**ADDENDUM
NO. 01**

Edwardsburg Public Schools – Middle School and High School Mechanical Upgrades

ADDENDUM NO. 2

PROJECT: **Edwardsburg Middle School – Mechanical Upgrades**
69410 Section St.
Edwardsburg, MI 49112

SHEET NUMBER
E 201C

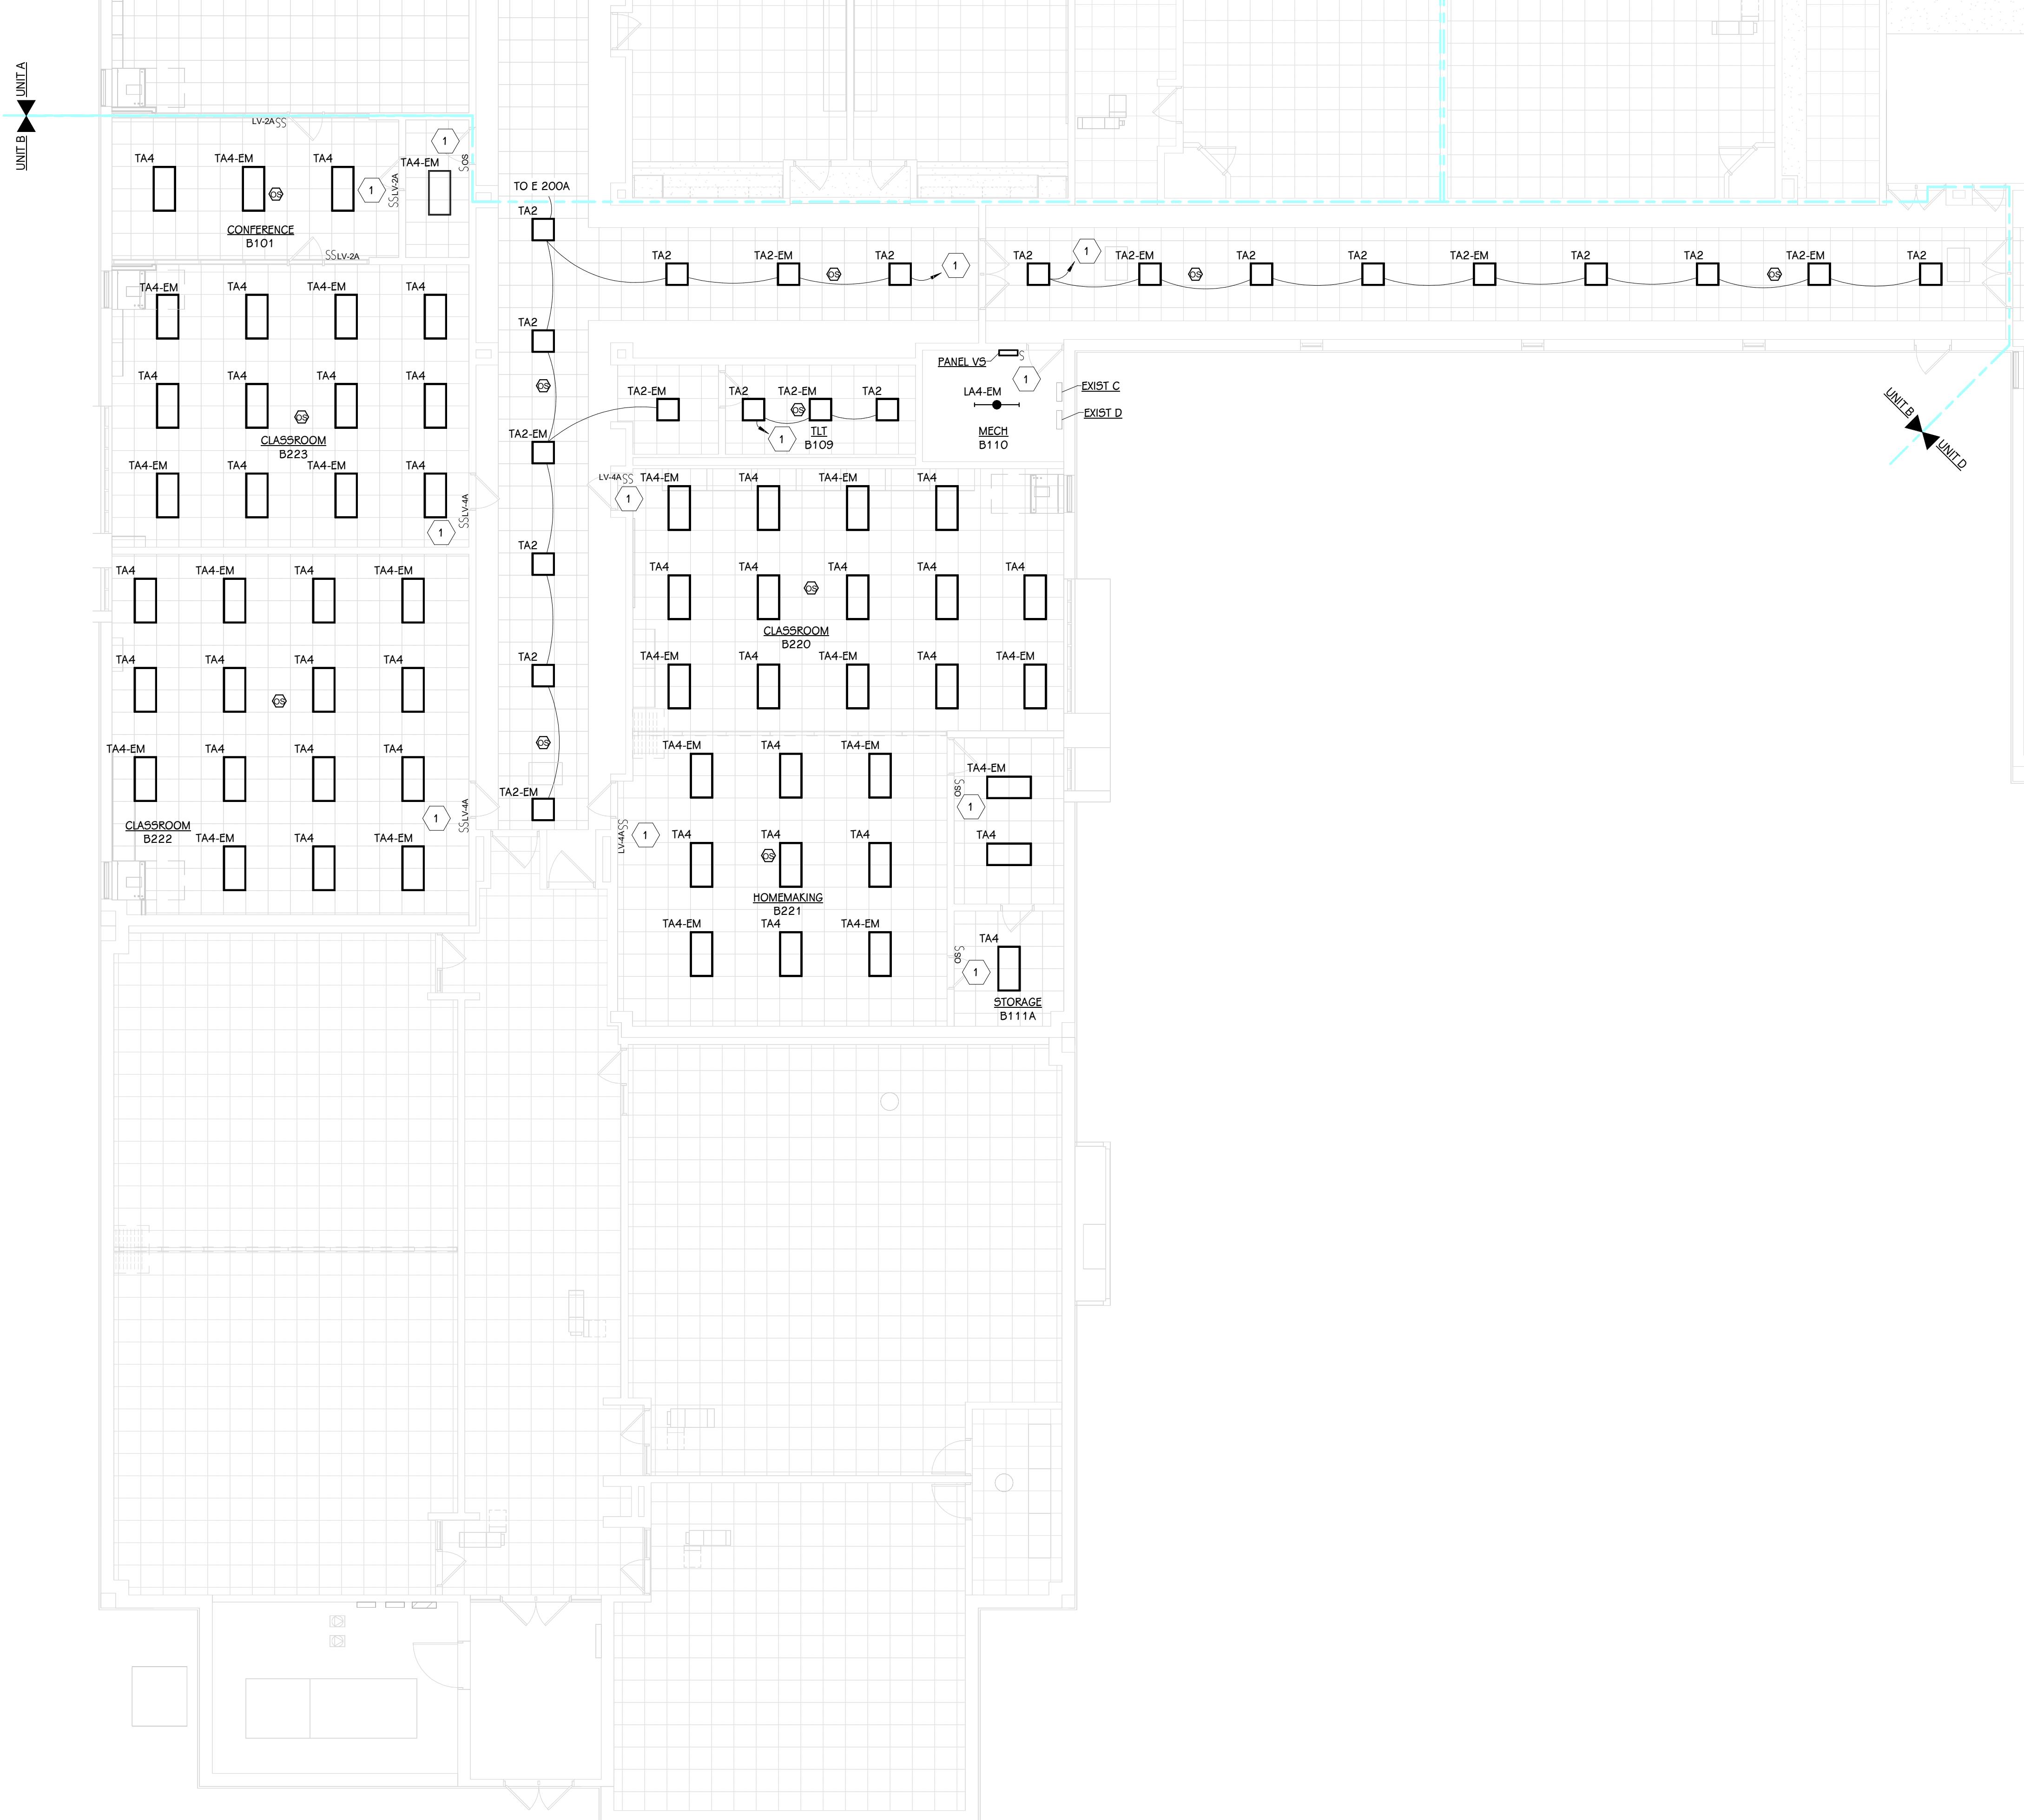
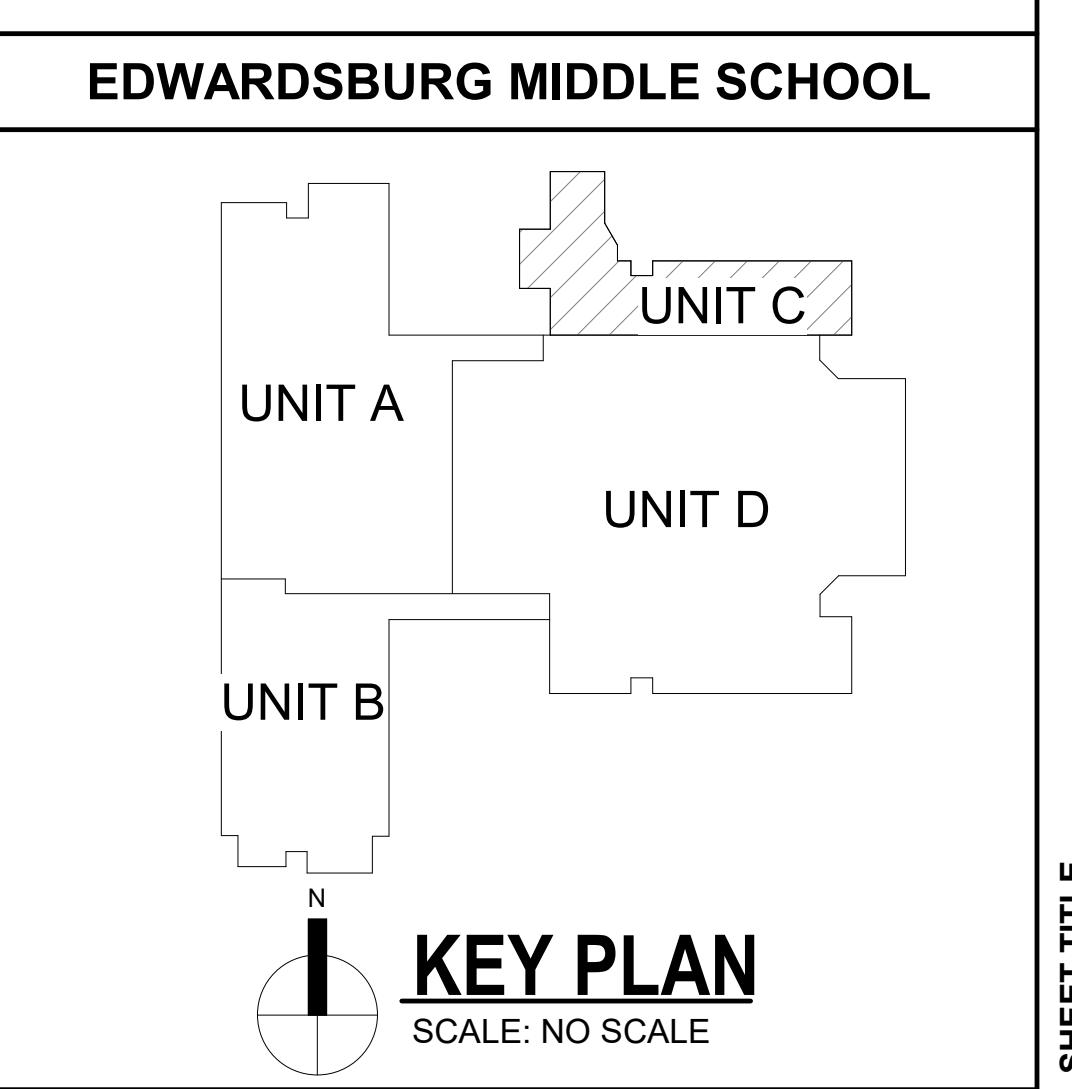
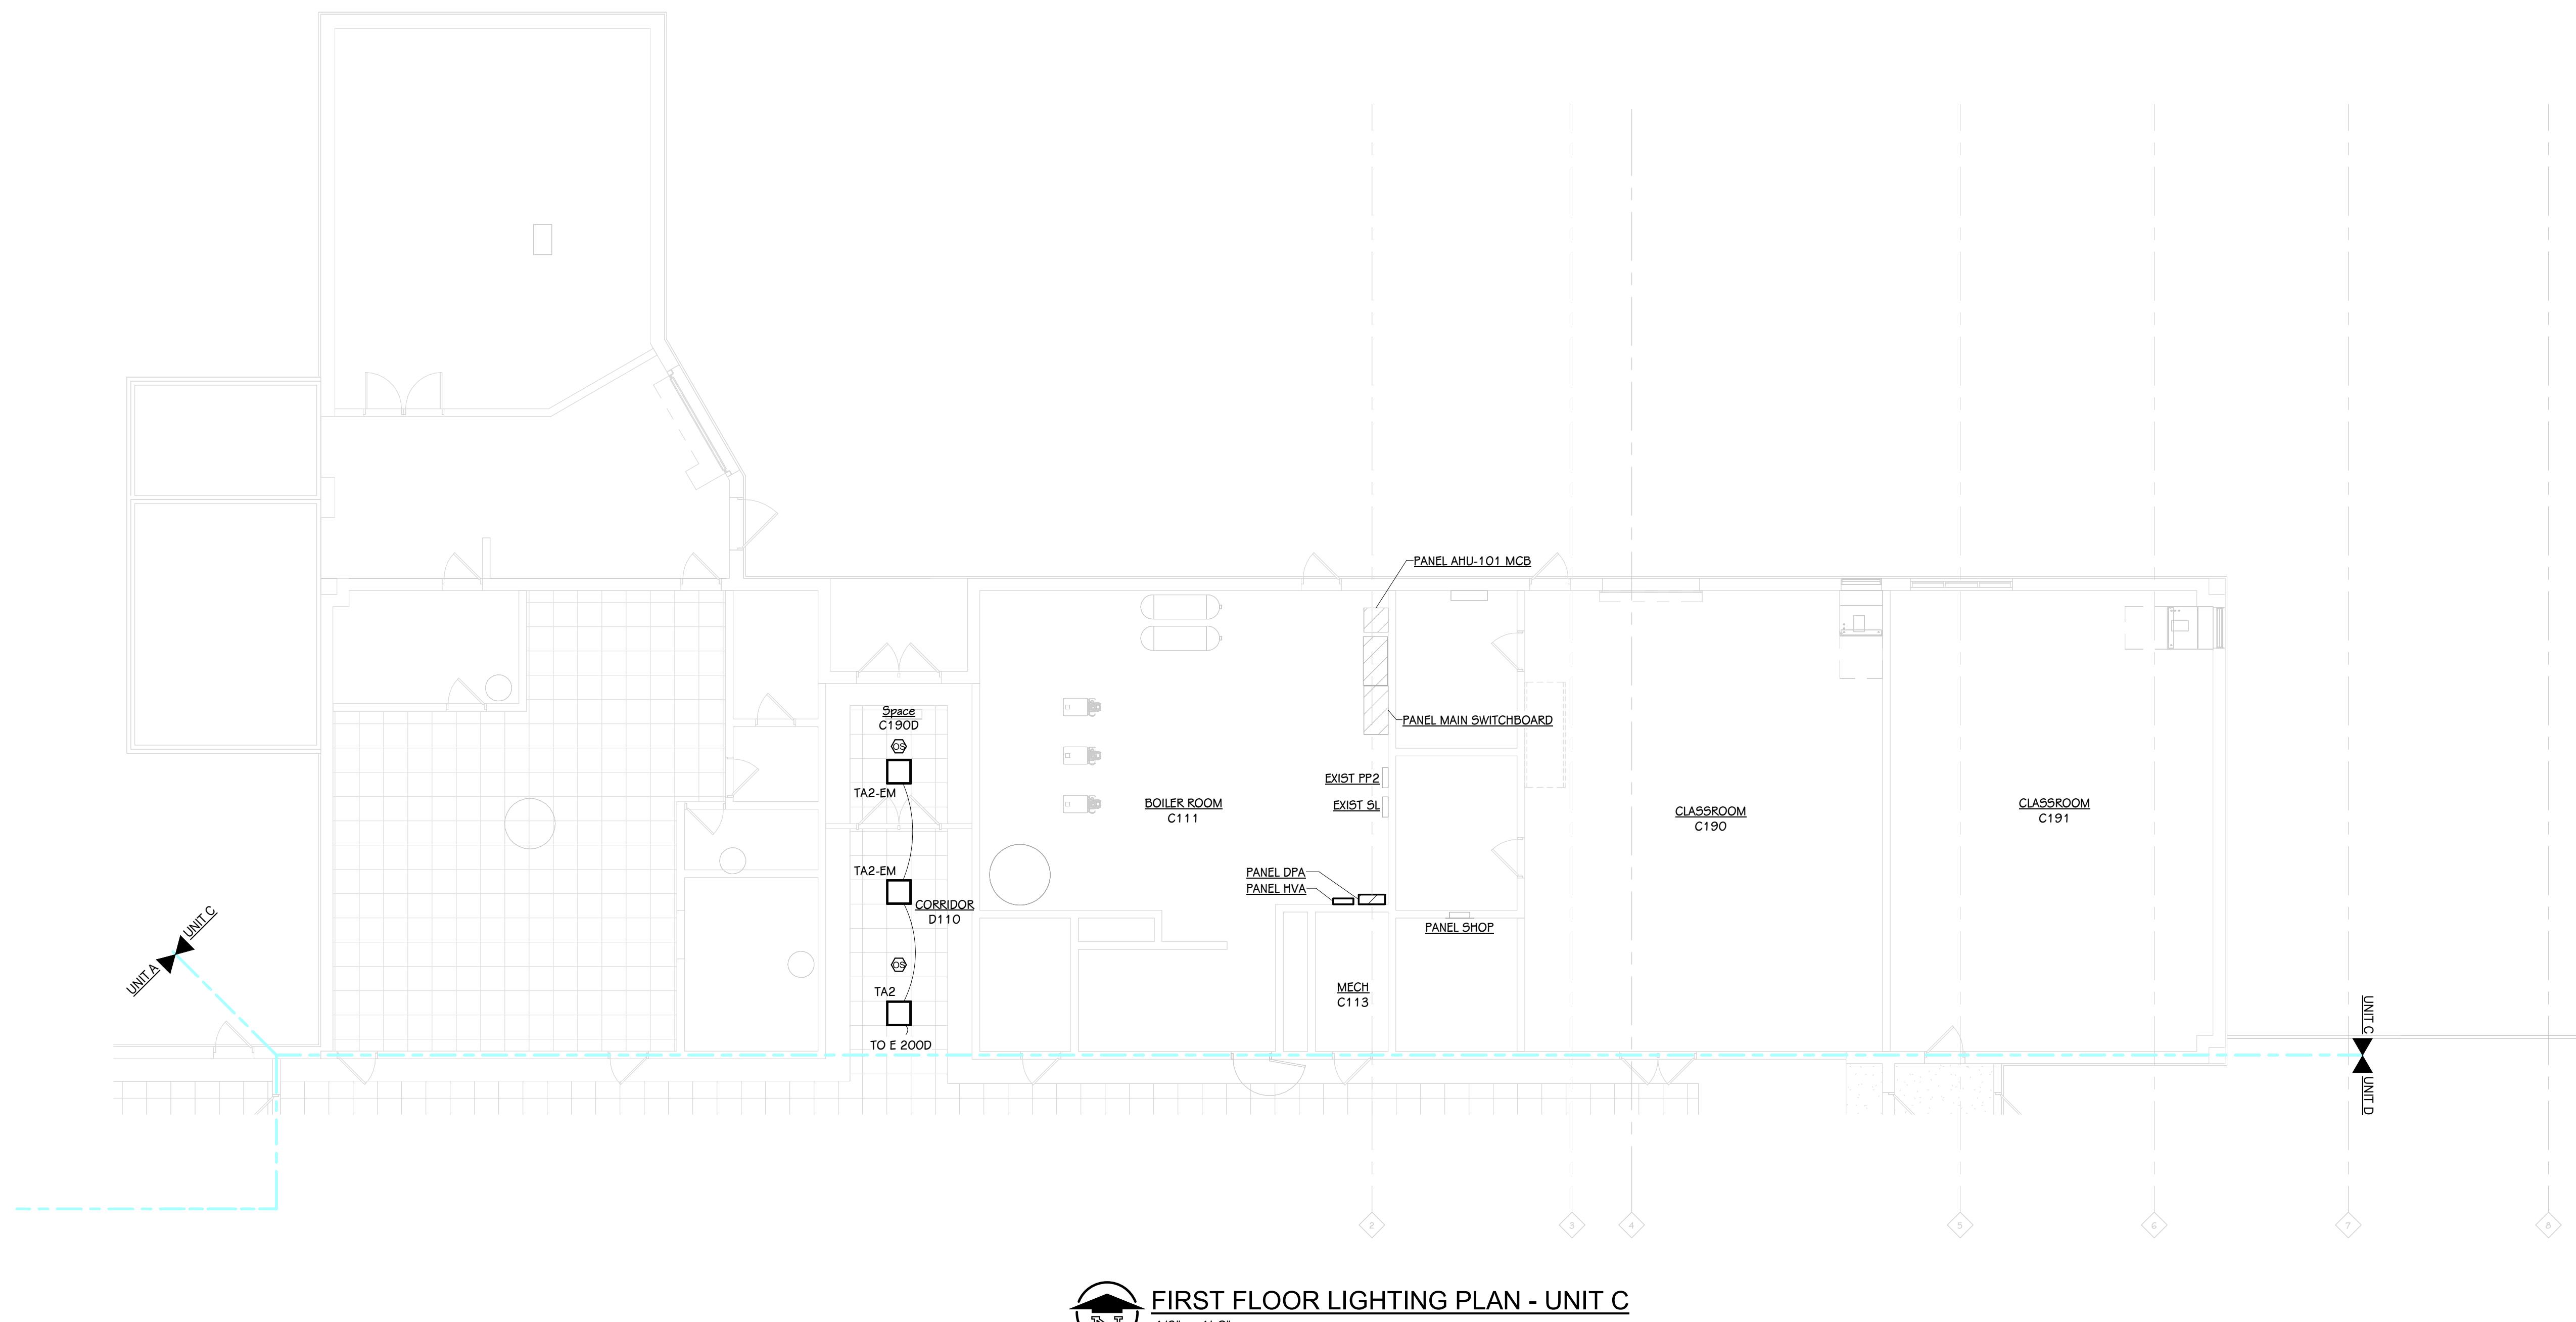
E 201A, E 201B, E 201C, and E 201D – Added new lighting drawings.
